UNITED STATES ENVIRONMENTAL PROTECTION AGENCY
REGION 8

RE: Windy Gap Firing Project, Northern
Colorado, Draft Environmental Impact
Statement, CEQ #20080333

EPA's Detailed Comments
Windy Gap Firing Project (WGFP) DEIS

Figure 1: Instantaneous peak flows from the USGS gage at Hot Sulphur Springs from 1904-1994. The study period for WGFP hydrologic analyses began in 1950.

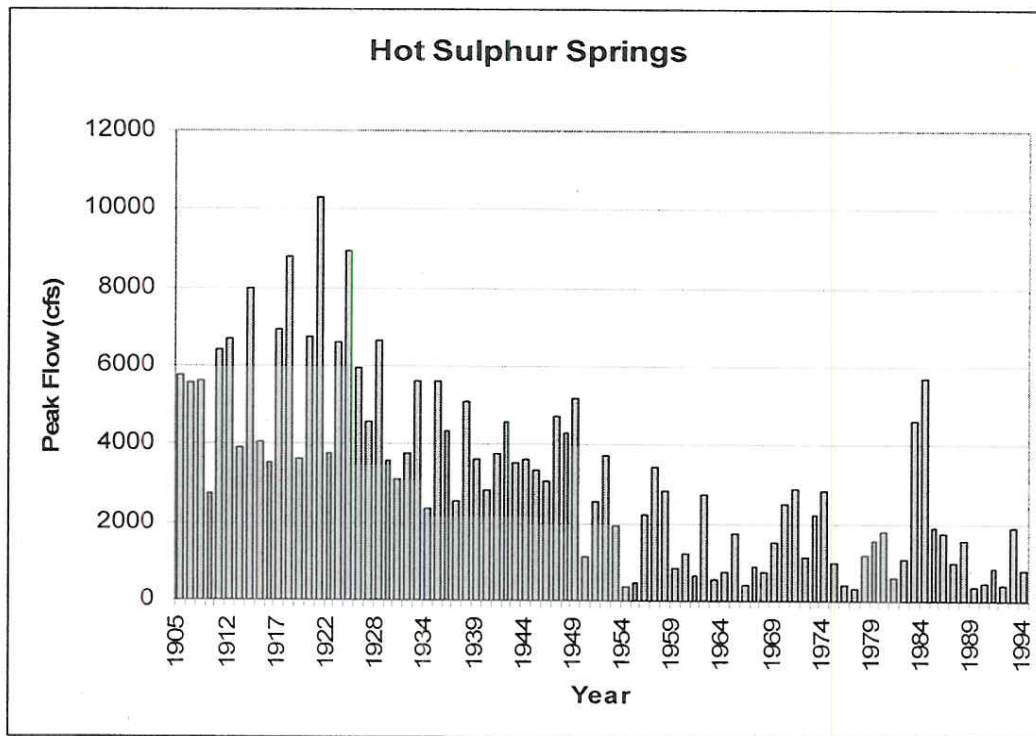
This project's impacts to the Colorado River, coupled with other reasonably foreseeable actions, could be severe, with irreparable harm done. EPA has objections to the cumulative impacts to the Colorado River. We believe much more attention should be given to what these projects are doing in total to the Colorado River. EPA recognizes that the existing peak flow conditions on the Colorado River are very different than historical conditions (Figure 1, Table 1), and is concerned that further reductions to the existing hydrograph will reduce the resiliency of the system and place the system at much higher risk of threshold (non-linear) changes to the aquatic community.

Throughout the DEIS there are references to the project's direct and indirect impacts to stream morphology, water quality and aquatic life as minor, and that cumulative effects are similar to the direct effects. EPA believes that when the impacts of this project are analyzed in combination with past and reasonably foreseeable actions, the impacts reach a level of significance that is objectionable. EPA believes that it is likely that the proposed project will have serious adverse effects on aquatic ecosystem diversity, productivity and stability not analyzed sufficiently in the DEIS.

EPA is concerned that the cumulative effects analysis did not consider the potential for threshold (non-linear) responses within the Colorado River. The impacts of the project are exacerbating current hydrologic conditions associated with the operation of diversion within the Upper Colorado Basin. Incremental or piecemeal movement towards a reduced hydrograph with altered temporal variation increases the likelihood for the system to approach a threshold point beyond which the system may exhibit dramatic changes, potentially including loss of native fish species. The EIS should assess the long-term cumulative impacts and uncertainty in their predicted responses. An additional component of a cumulative impacts analysis should address the potential for threshold responses.

The DEIS acknowledges the importance of bankfull and channel maintenance flows in the DEIS. EPA suggests that BOR address a minimum mitigation that is equivalent to that flow volume (e.g., 1,240 cfs for bankfull discharge) instead of the 450 cfs of the existing mitigation.
